CITY OF BURLINGTON
BUILDING SERVICES DEPARTMENT
REVIEWED
FOR PERMIT ISSUANCE
DATE April 7, 2021
PERMIT NUMBER 21-002221
EXAM ISSUED BY

BURLINGTON CENTRAL H.S. RENOVATIONS

No.	Revisions	Date
1	ISSUED FOR BUILDING PERMIT	2021/01/25

Drawing Title:
FIRST FLOOR NEW LAYOUTS

1 A200 GROUND FLOOR - NEW OFFICE AREA LAYOUT 1:50

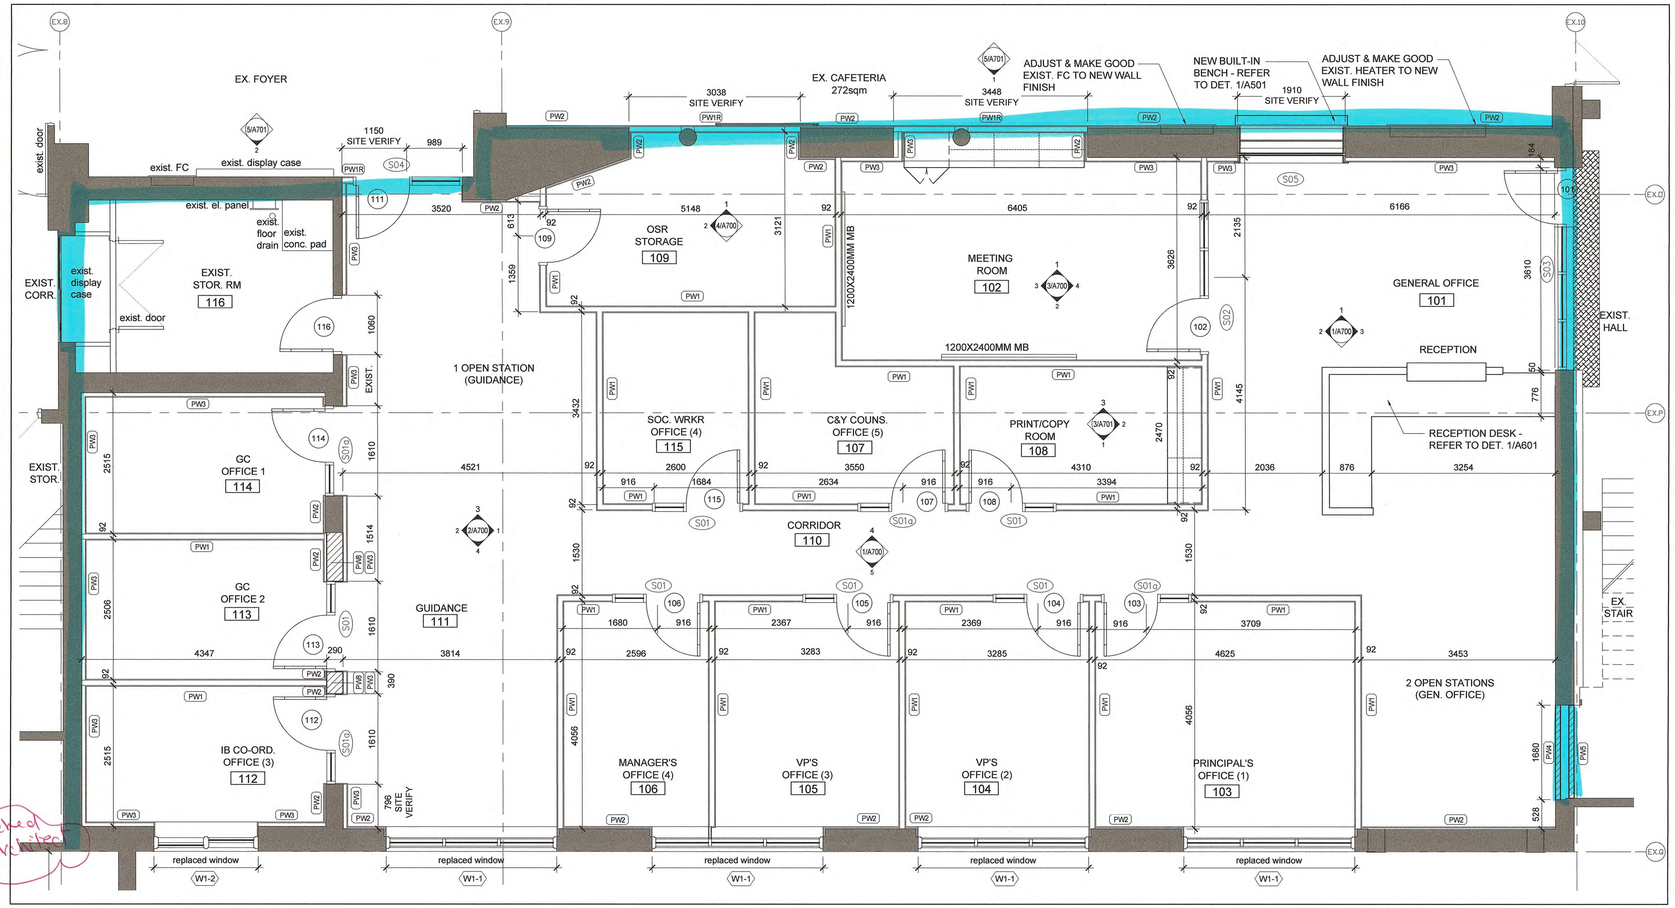
Please see attached letter from Architect

3 A200 GROUND FLOOR - NEW UNIVERSAL WASHROOM 1:50

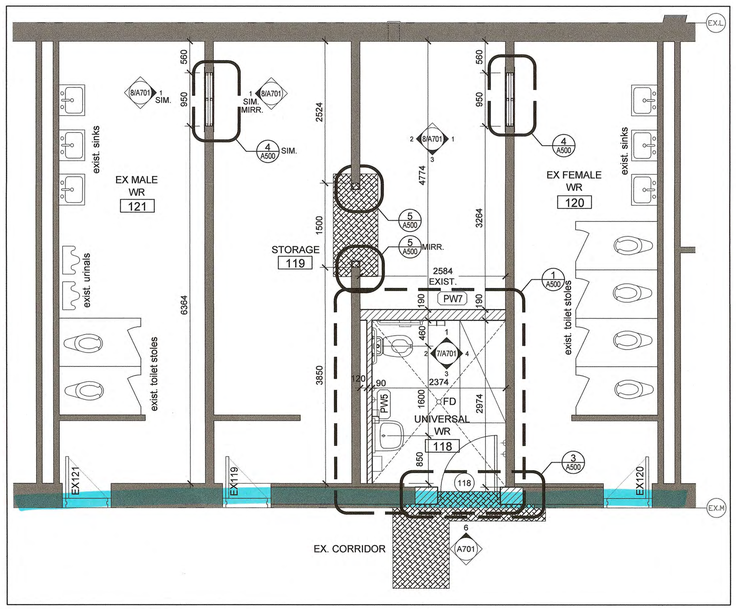
See attached letter from Architect

1 / A300 FIRST FLOOR - NEW OFFICE AREA RCP 1:100

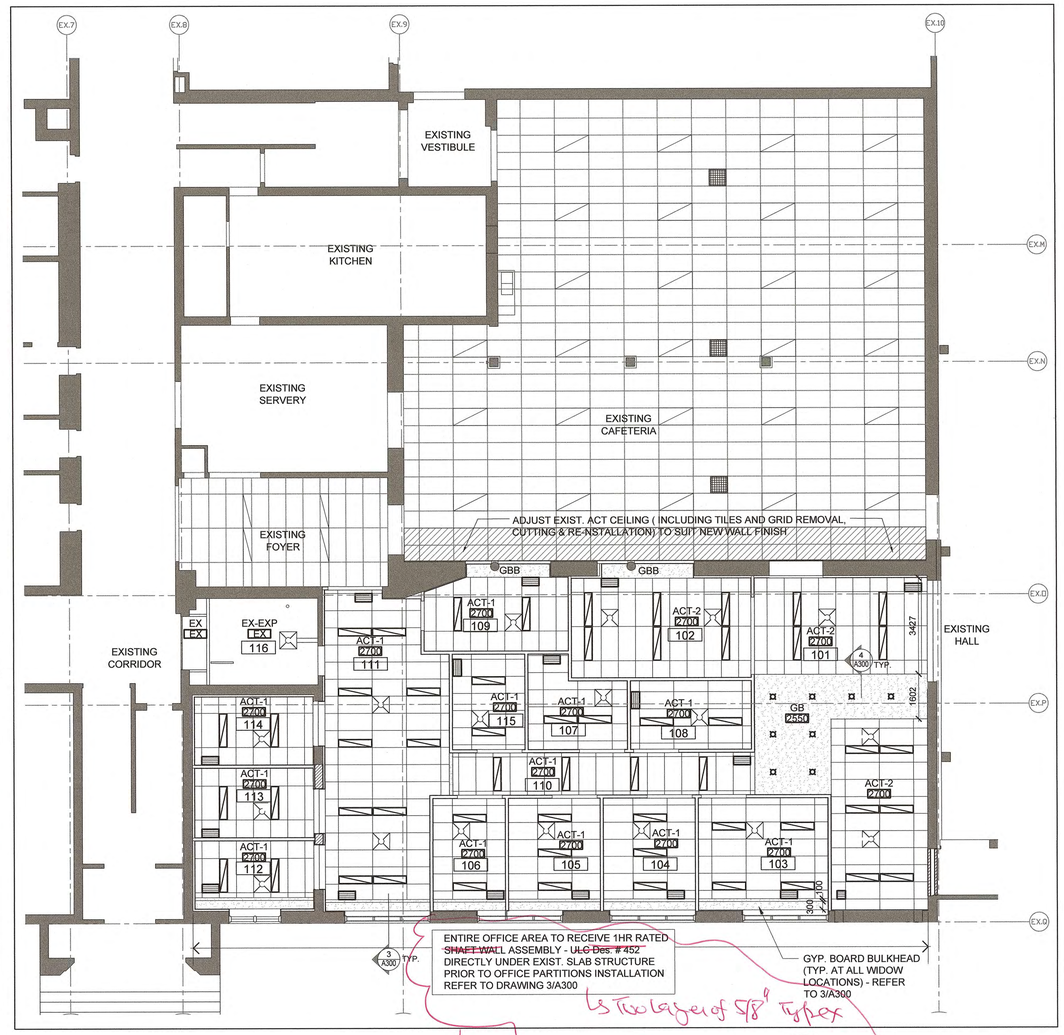
See attached Revised Sketch showing Protection of Existing Floor Assembly.

Is Two Layer of 5/8" Type X

1 / A500 **UNIVERSAL WASHROOM (RM118) FLOOR PLAN ENLARGEMENT**
1:20

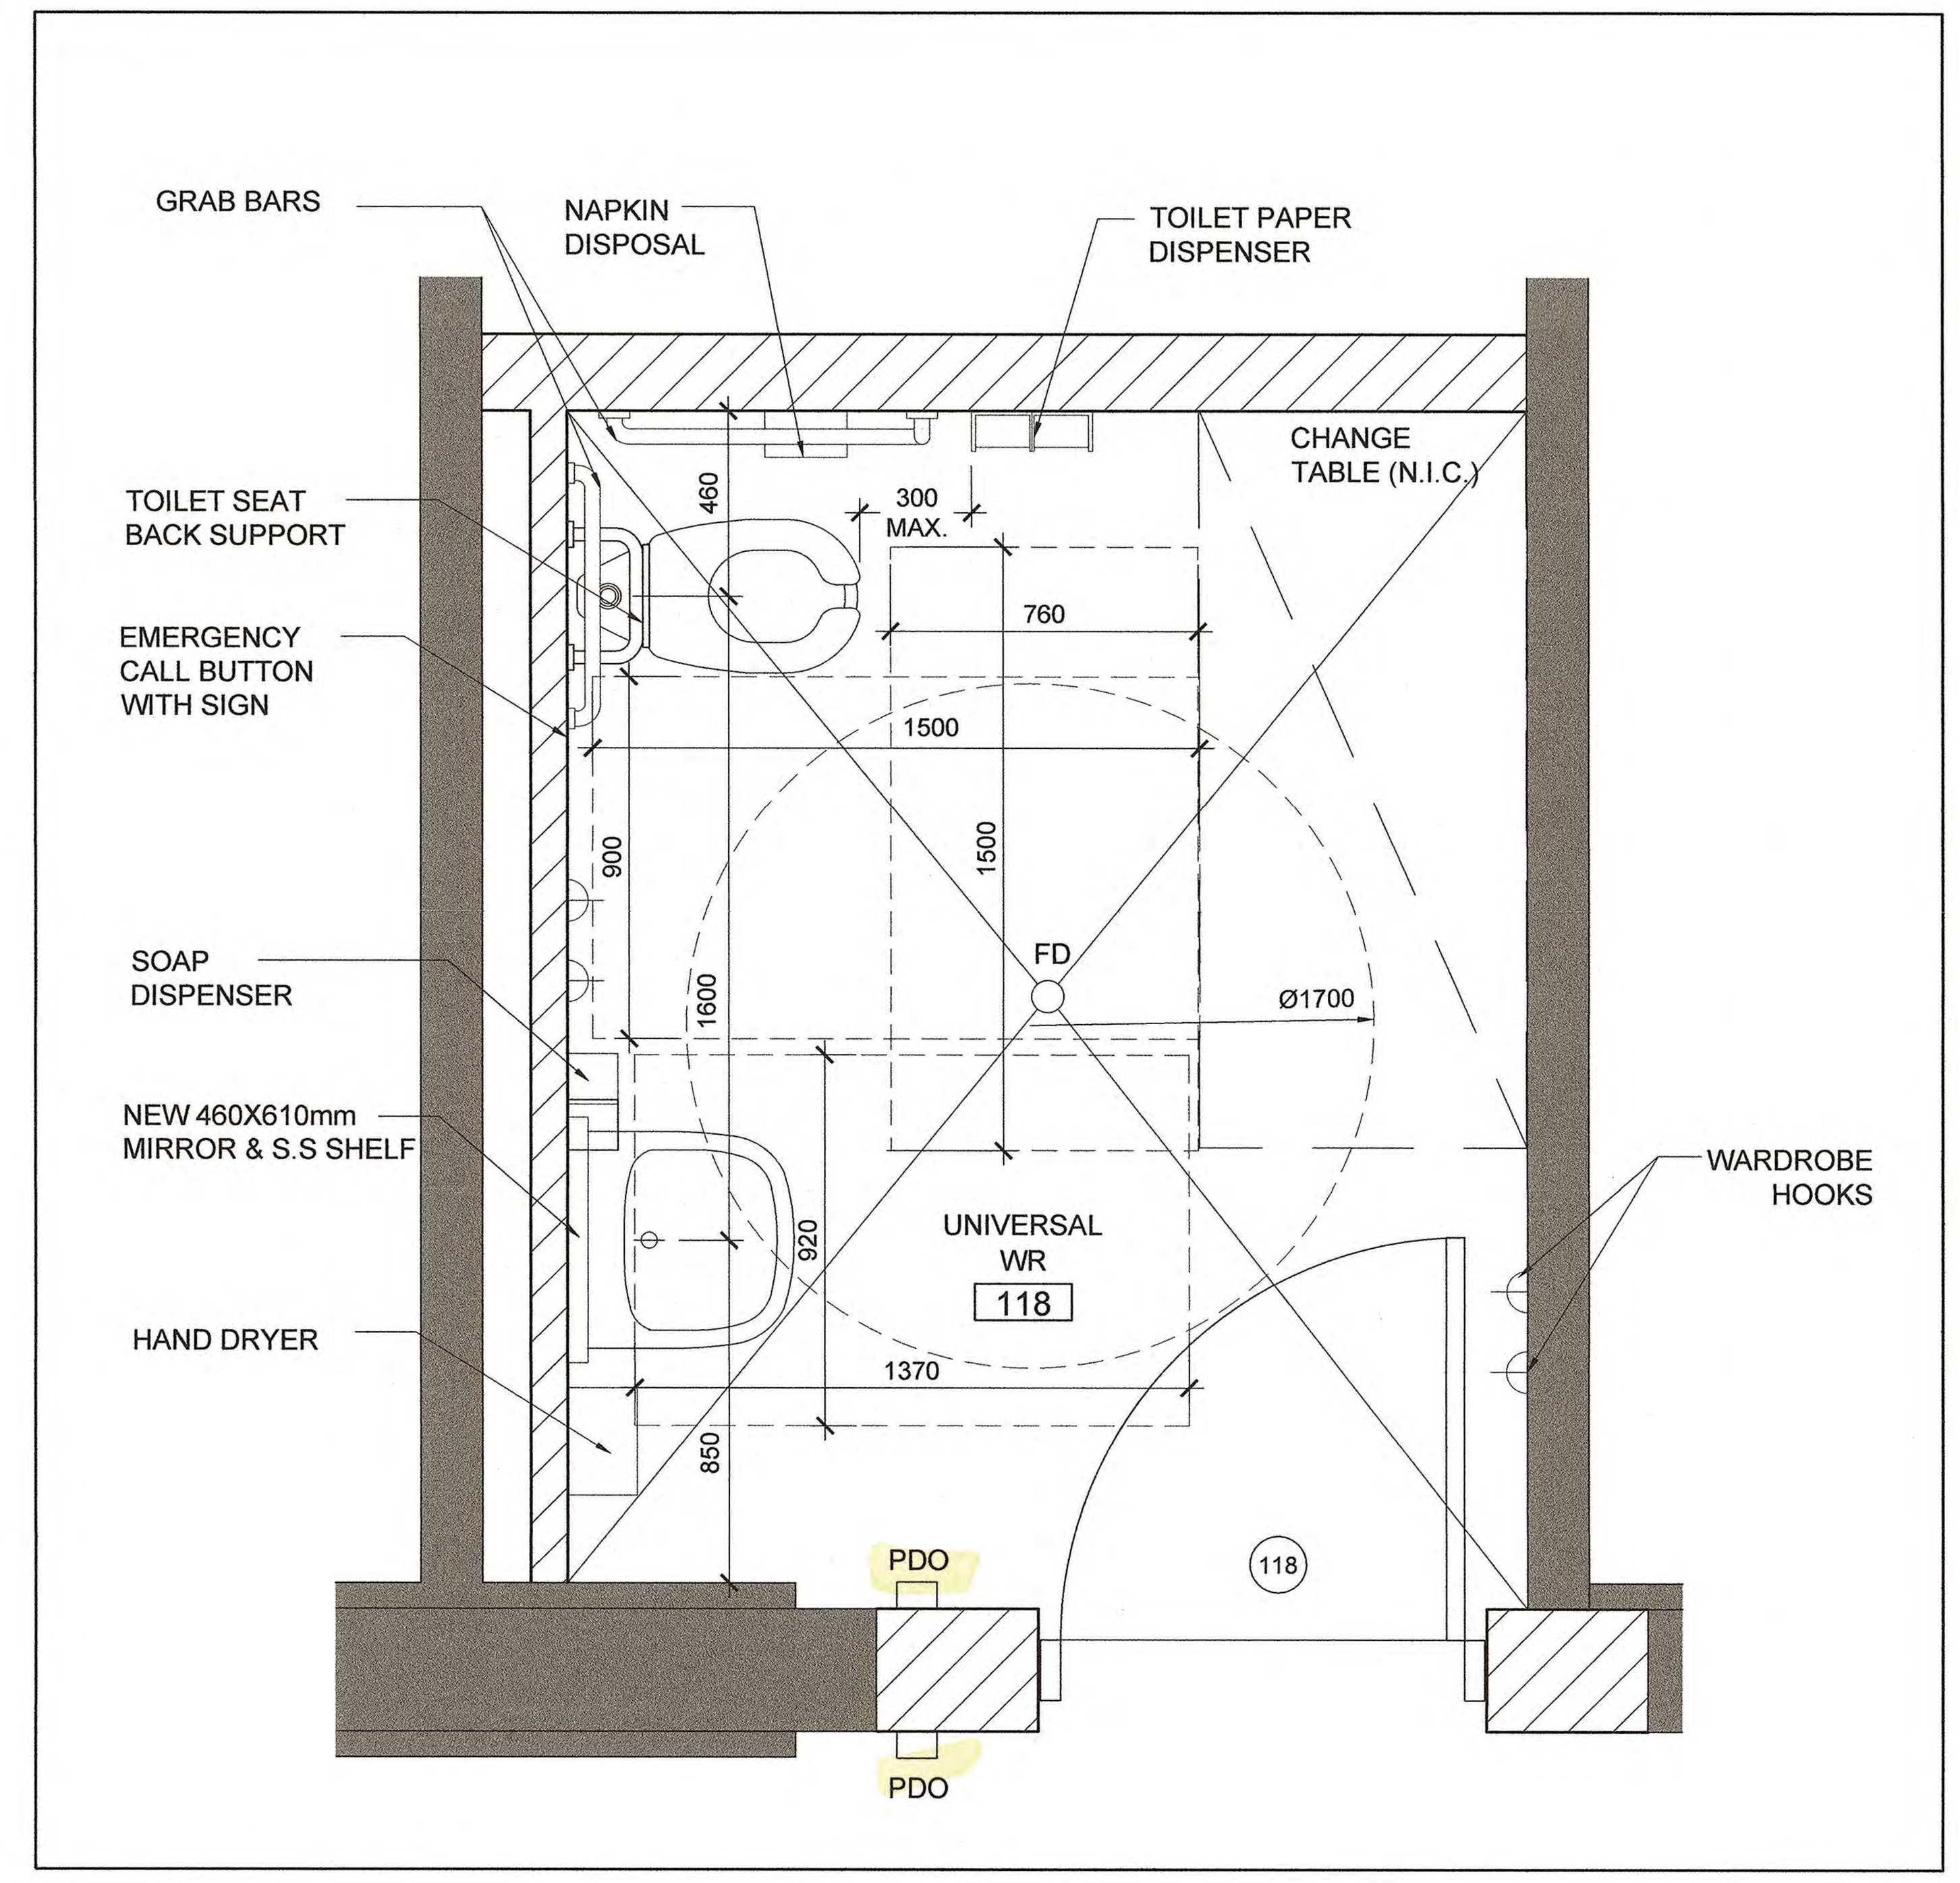
UNIVERSAL WASHROOMS to comply to with Div. B, 3.8.3.12. Ontario Building Code 2012 (~~See attached sheet~~)

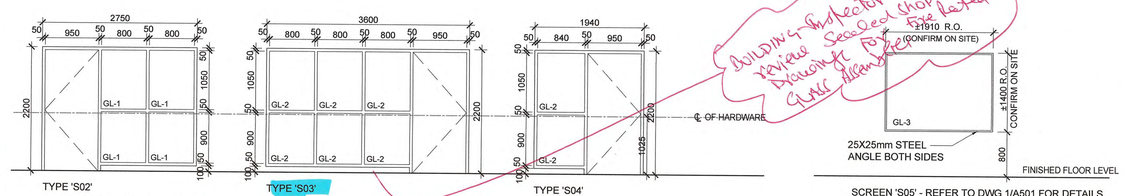
Building Inspector to review Sealed Shop Drawings for Fire Rated Glass Assemblies
